HISTORIC AND DESIGN REVIEW COMMISSION

February 07, 2024

HDRC CASE NO: 2024-003
ADDRESS: 1024 BURNET ST
LEGAL DESCRIPTION: NCB 1660 BLK H LOT E 16.2 FT OF N 120 FT OF 6 & W 39 FT OF N 120 FT OF 7
ZONING: R-6, H
CITY COUNCIL DIST.: 2
DISTRICT: Dignowity Hill Historic District
APPLICANT: Jose Alex Barrera | Elite Remodeling and Flooring LLC
OWNER: Tammy De Long | ITB Enterprises Inc.
TYPE OF WORK: Wholesale window replacement and fenestration modifications
APPLICATION RECEIVED: January 3, 2024
60-DAY REVIEW: March 3, 2024
CASE MANAGER: Bryan Morales

1. Replace all the windows on the property.
2. Modify the existing fenestration pattern on each façade.

North Facade

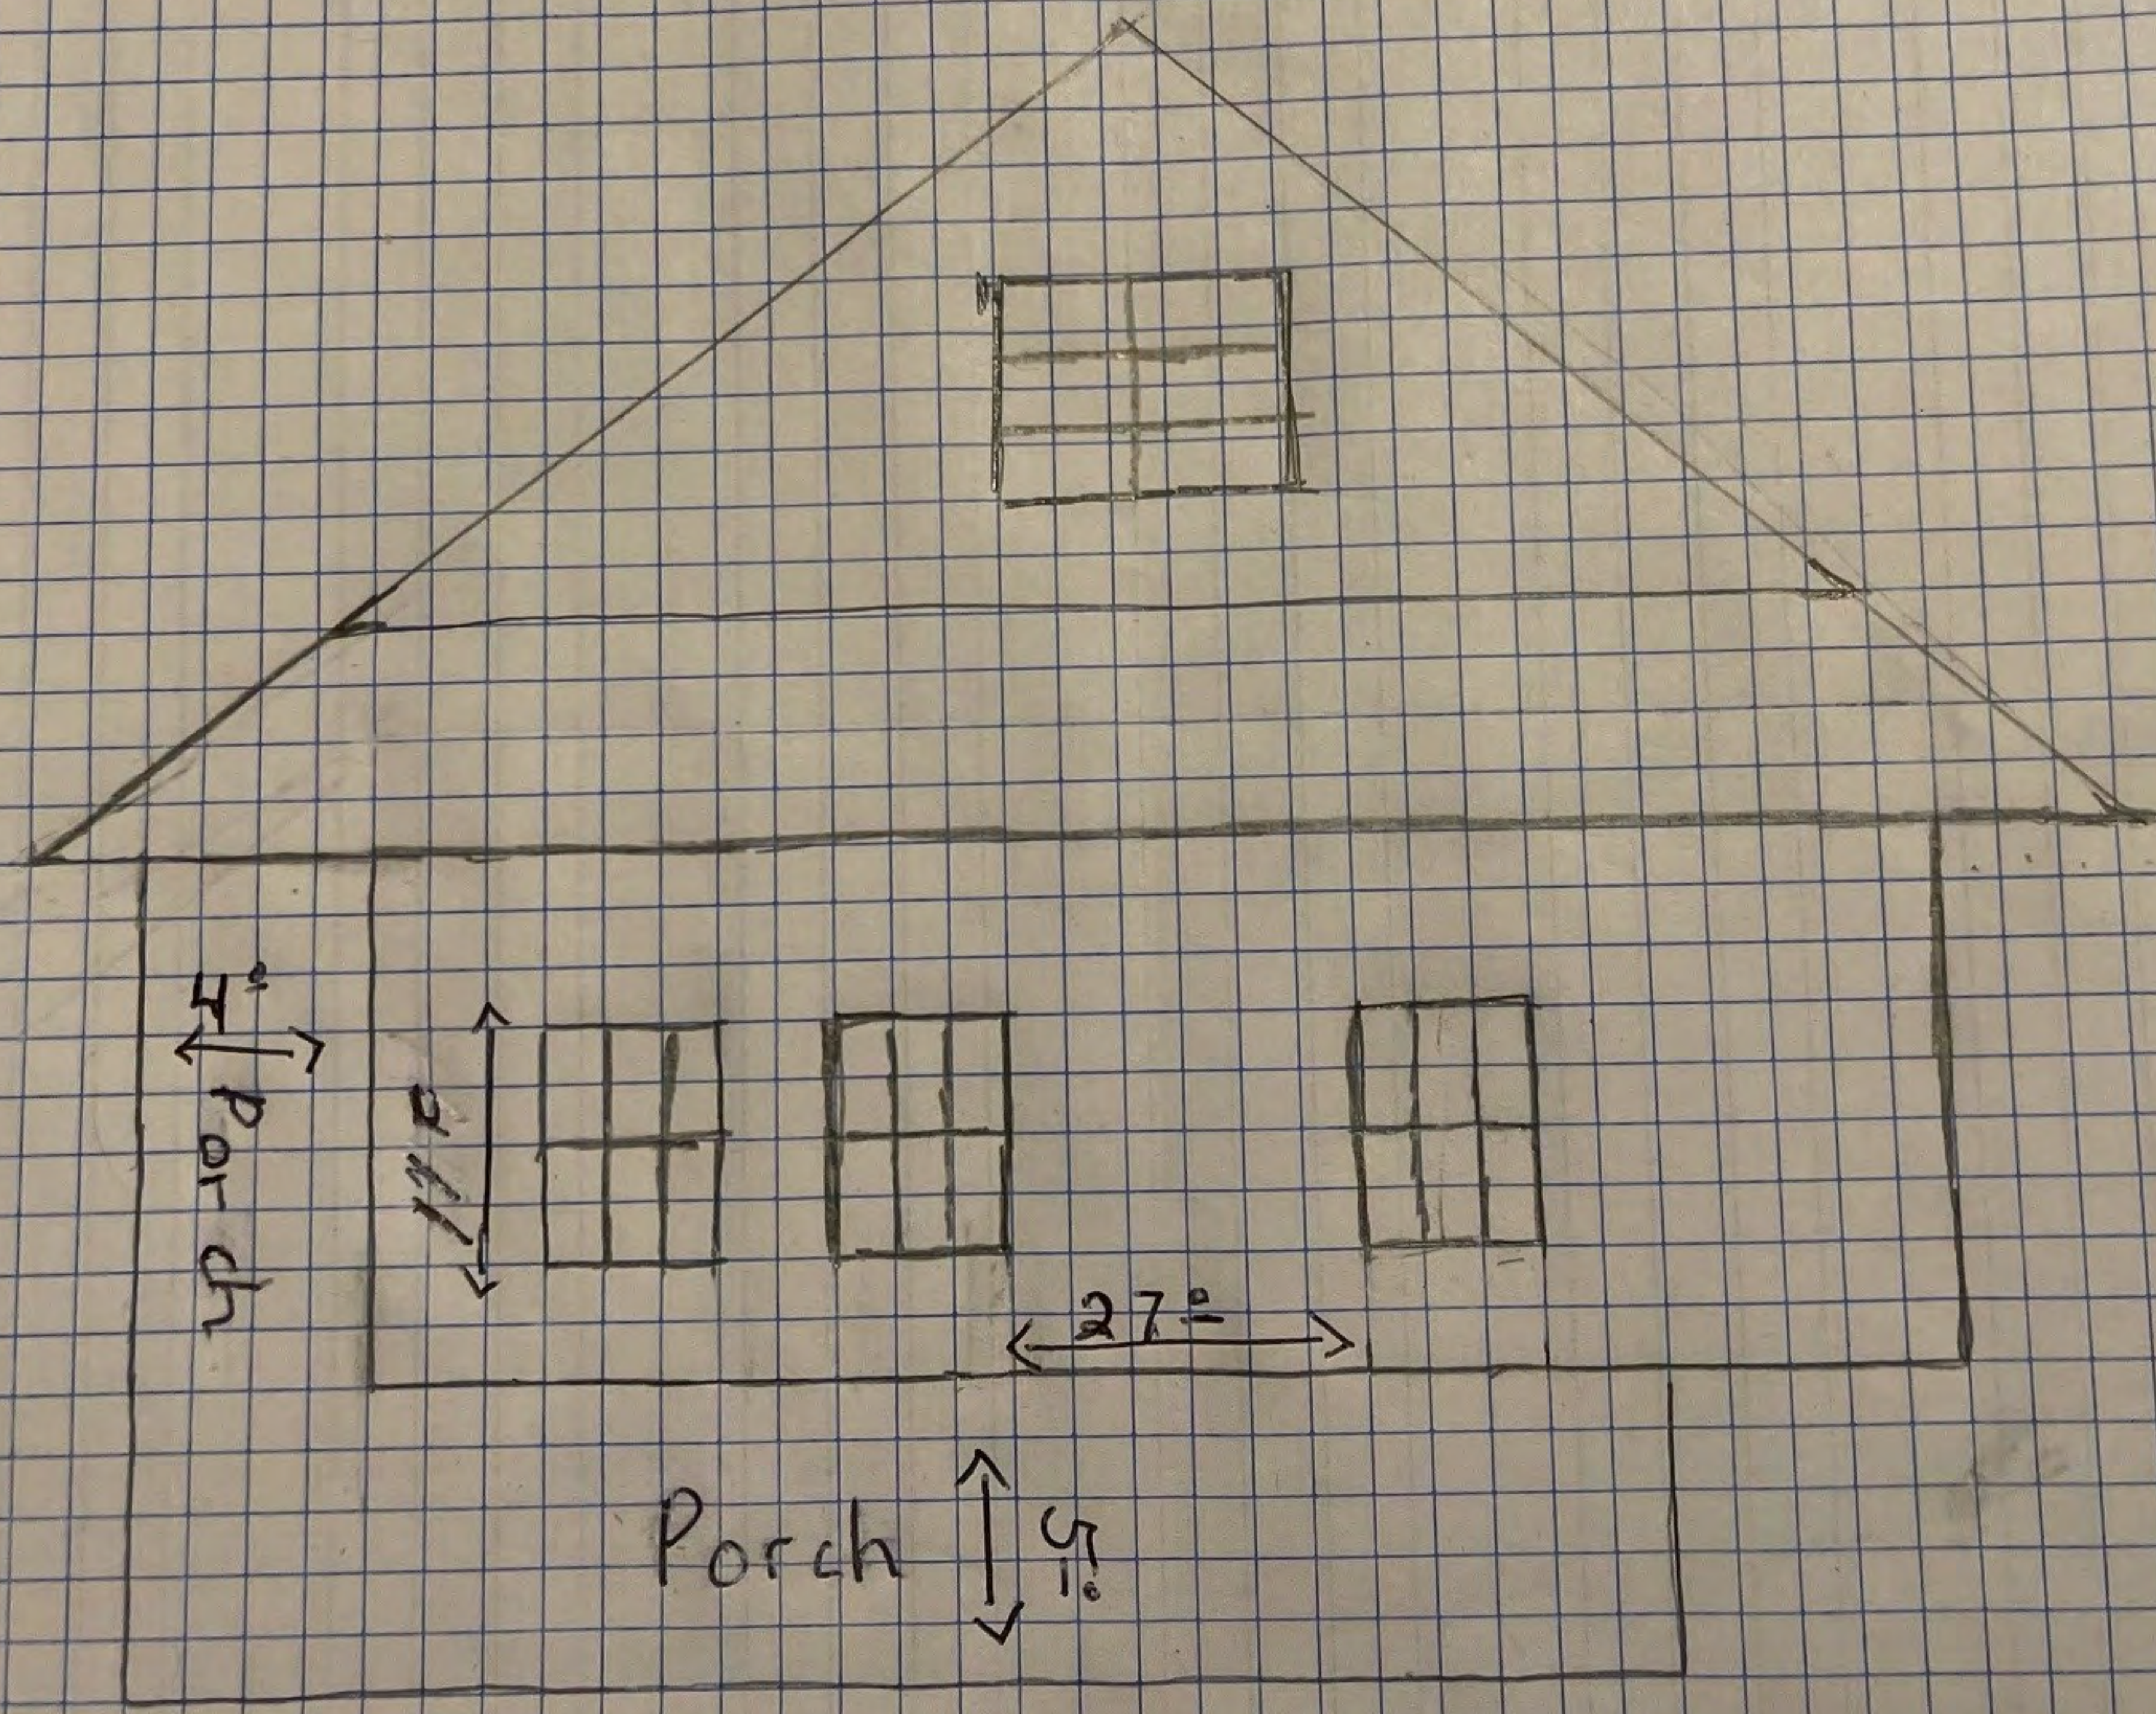
- h. **FENESTRATION MODIFICATIONS (NORTH FAÇADE)** – The applicant is requesting approval to modify the existing two window openings on the first floor of the north façade. The Historic Design Guidelines for Exterior Maintenance and Alterations 6.A.i. states to preserve existing window and door openings, to avoid enlarging or diminishing to fit stock sizes or air conditioner units, to avoid filling in historic door or window openings, and to avoid creating new primary entrances or window openings on the primary façade or where visible from the public

right-of-way. Exterior Maintenance and Alterations 6.B.iv. states to install new windows to match the historic or existing windows in terms of size, type, configuration, material, form, appearance, and detail when original windows are deteriorated beyond repair. Exterior Maintenance and Alterations 6.B.vii. states to replace non-historic incompatible windows with windows that are typical of the architectural style of the building. The applicant has not provided a proposed window replacement or detail regarding its dimensions. A request to return the north façade to its original configuration is eligible for administrative approval. Staff finds the proposed fenestration modifications to the north façade does not conform to guidelines.

Staff does not recommend approval of item 2, based on findings a and h through k. Staff recommends the applicant either retain the existing fenestration pattern or return to the original fenestration pattern.

East Facade

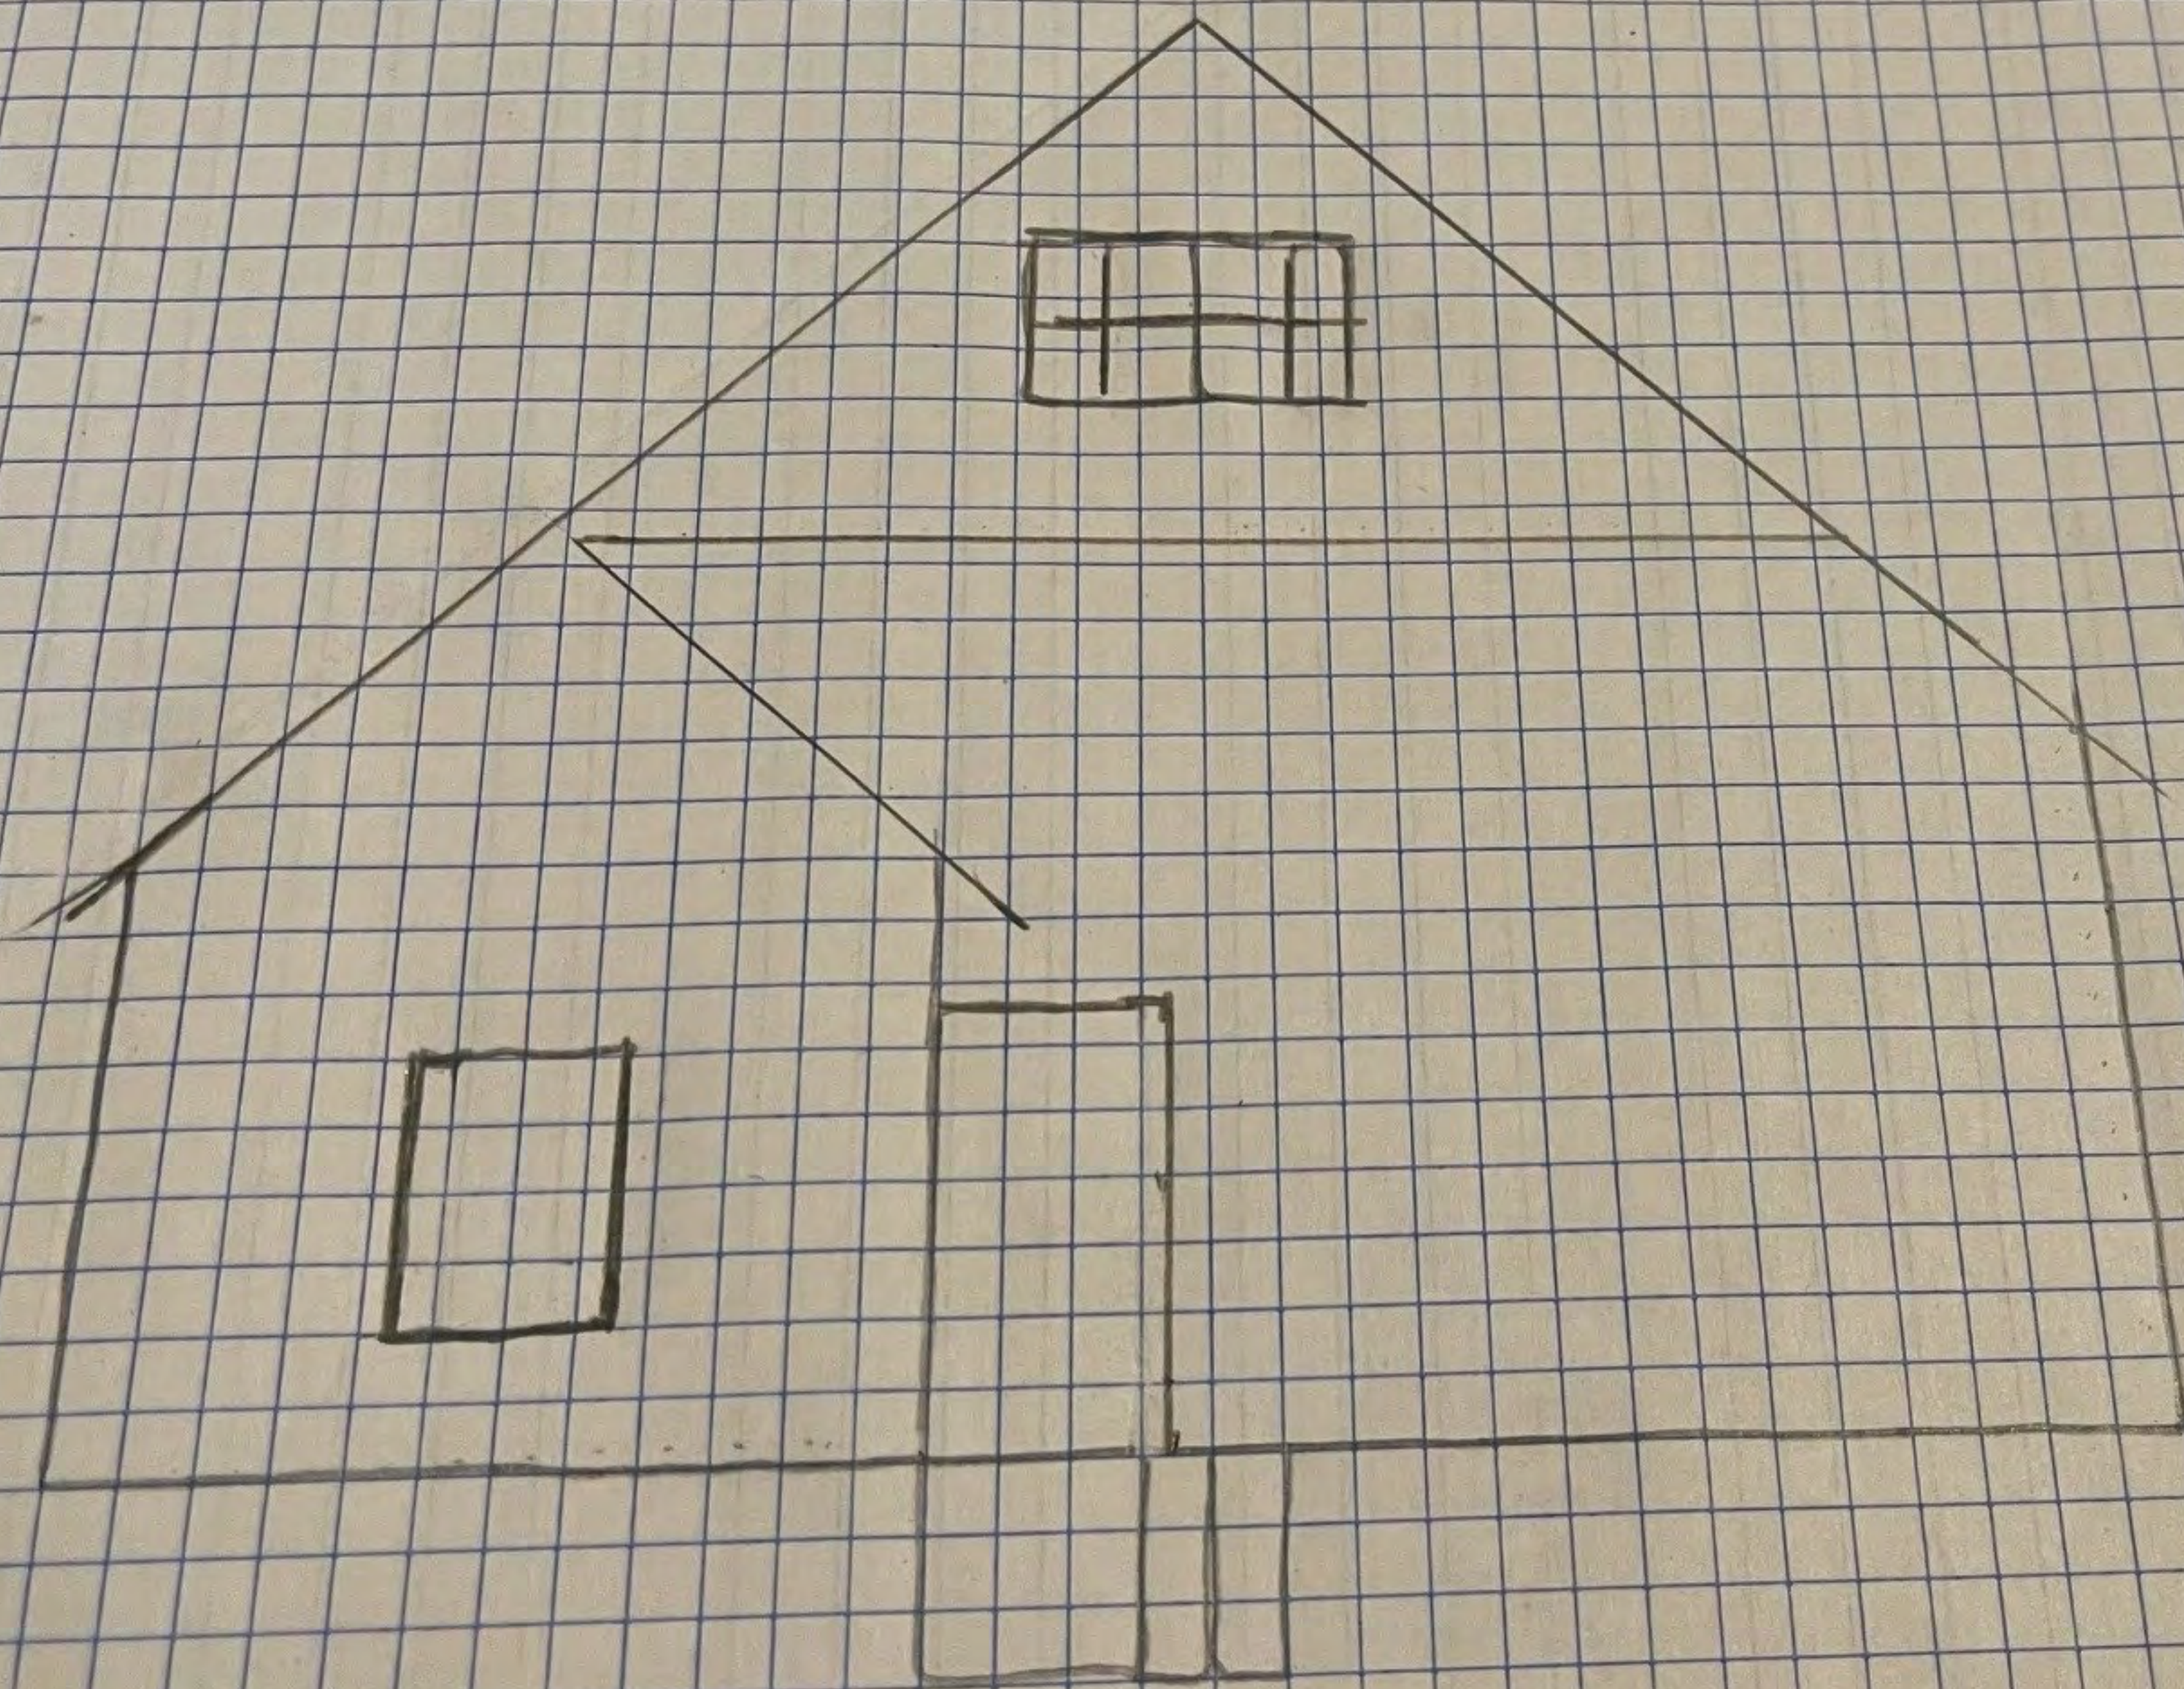
- i. FENESTRATION MODIFICATIONS (EAST FAÇADE) – The applicant is requesting approval to replace one door with a window, combine two window openings between the two existing side doors, and combine two window openings on the rear addition’s east façade. Exterior Maintenance and Alterations 6.A.i. states to preserve existing window and door openings, to avoid enlarging or diminishing to fit stock sizes or air conditioner units, to avoid filling in historic door or window openings, and to avoid creating new primary entrances or window openings on the primary façade or where visible from the public right-of-way. Exterior Maintenance and Alterations 6.B.iv. states to install new windows to match the historic or existing windows in terms of size, type, configuration, material, form, appearance, and detail when original windows are deteriorated beyond repair. Exterior Maintenance and Alterations 6.B.vii. states to replace non-historic incompatible windows with windows that are typical of the architectural style of the building. The applicant has not provided a proposed window replacement or detail regarding its dimensions. Staff finds the proposed fenestration modifications to the east façade does not conform to guidelines.

- j. FENESTRATION MODIFICATIONS (SOUTH FAÇADE) – The applicant is requesting approval to infill one window opening and install one window opening on the south façade. Exterior Maintenance and Alterations 6.A.i. states to preserve existing window and door openings, to avoid enlarging or diminishing to fit stock sizes or air conditioner units, to avoid filling in historic door or window openings, and to avoid creating new primary entrances or window openings on the primary façade or where visible from the public right-of-way. Exterior Maintenance and Alterations 6.B.iv. states to install new windows to match the historic or existing windows in terms of size, type, configuration, material, form, appearance, and detail when original windows are deteriorated beyond repair. Exterior Maintenance and Alterations 6.B.vii. states to replace non-historic incompatible windows with windows that are typical of the architectural style of the building. The applicant has not provided a proposed window replacement or detail regarding its dimensions. Staff finds the proposed fenestration modifications to the south façade does not conform to guidelines.

West Facade

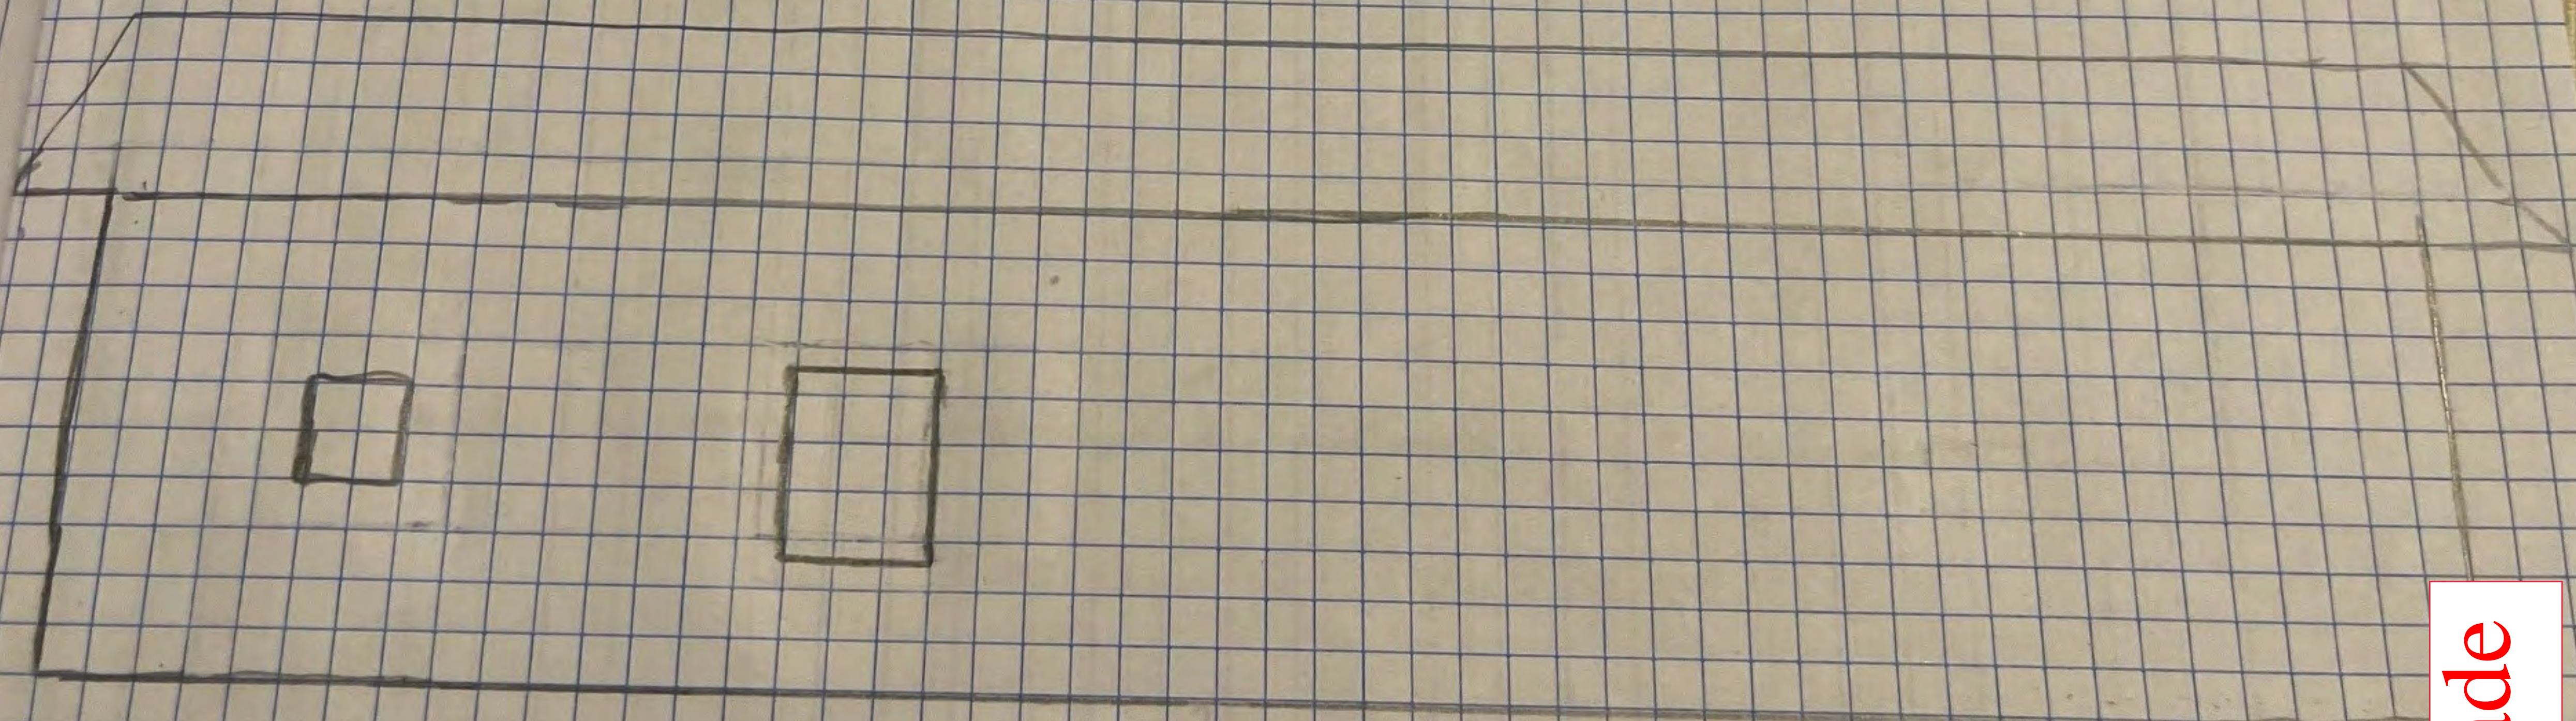
- k. FENESTRATION MODIFICATIONS (WEST FAÇADE) – The applicant is requesting approval to infill four window openings. Exterior Maintenance and Alterations 6.A.i. states to preserve existing window and door openings, to avoid enlarging or diminishing to fit stock sizes or air conditioner units, to avoid filling in historic door or window openings, and to avoid creating new primary entrances or window openings on the primary façade or where visible from the public right-of-way. Exterior Maintenance and Alterations 6.B.iv. states to install new windows to match the historic or existing windows in terms of size, type, configuration, material, form, appearance, and detail when original windows are deteriorated beyond repair. Exterior Maintenance and Alterations 6.B.vii. states to replace non-historic incompatible windows with windows that are typical of the architectural style of the building. The applicant has not provided a proposed window replacement or detail regarding its dimensions. Staff finds the proposed fenestration modifications to the west façade does not conform to guidelines.
